Access Compliance Report

Public Rights-of-Way

(Curb Ramps)

Intersection ID: 52622	Main Street: HERITAGE_POND_DR	Cross Street: ALEXANDER_COMMONS_DR	Location: W
ADA ID: 60F111EE4342	Ramp Type: Perp	Initial Pass/Fail: Fail	Overall Compliance: No
Severity Score: 25			
Codes/Mitigation Info/Possible Solution		Field Measurements/Component Compliance

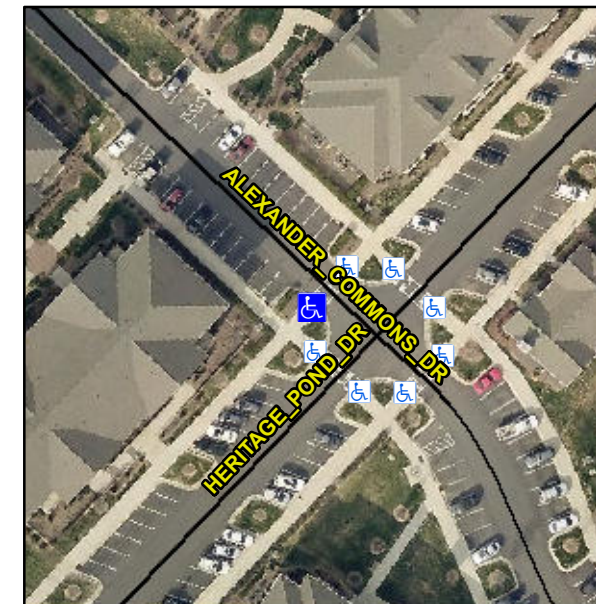
Surveyor Notes:

N/A

Compliance	Description	Data	Compliance	Description	Data
N/A	Ramp Length (in)	98.0	No	Ramp Slope (%)	17.9
Yes	Ramp Width (in)	105.5	Yes	Ramp XSlope (%)	0.9
N/A	Flare Type LT	N/A	N/A	Flare Type RT	N/A
N/A	Flare Slope LT (%)	N/A	N/A	Flare Slope RT (%)	N/A
N/A	Flare Traversable LT?	N/A	N/A	Flare Traversable RT?	N/A
N/A	Landing Length (in)	N/A	N/A	DWS Provided?	N/A
N/A	Landing Width (in)	N/A	N/A	DWS Contrast?	N/A
N/A	Landing Slope (%)	N/A	N/A	DWS Length (in)	N/A
N/A	Landing X Slope (%)	N/A	N/A	DWS Full Width?	N/A
N/A	Landing Curb? (Y/N)	N/A	N/A	DWS Offset (in)	N/A
N/A	Shared Landing?	N/A			
N/A	Gutter Ponding?	N/A	N/A	Gutter Slope (%)	N/A
N/A	Gutter Lip Ht (in)	N/A	N/A	Gutter X Slope (%)	N/A
N/A	Painted X Walk1?	Yes	N/A	Painted X Walk2?	N/A
	X Walk 1 Direction	To NE		X Walk 2 Direction	N/A
N/A	X Walk 1 Width (in)	94.5	N/A	X Walk 2 Width (in)	N/A
	X Walk 1 Slope (%)	0.7		X Walk 2 Slope (%)	N/A
	X Walk 1 X Slope (%)	0.8		X Walk 2 X Slope (%)	N/A

Remove & Replace Entire Ramp.
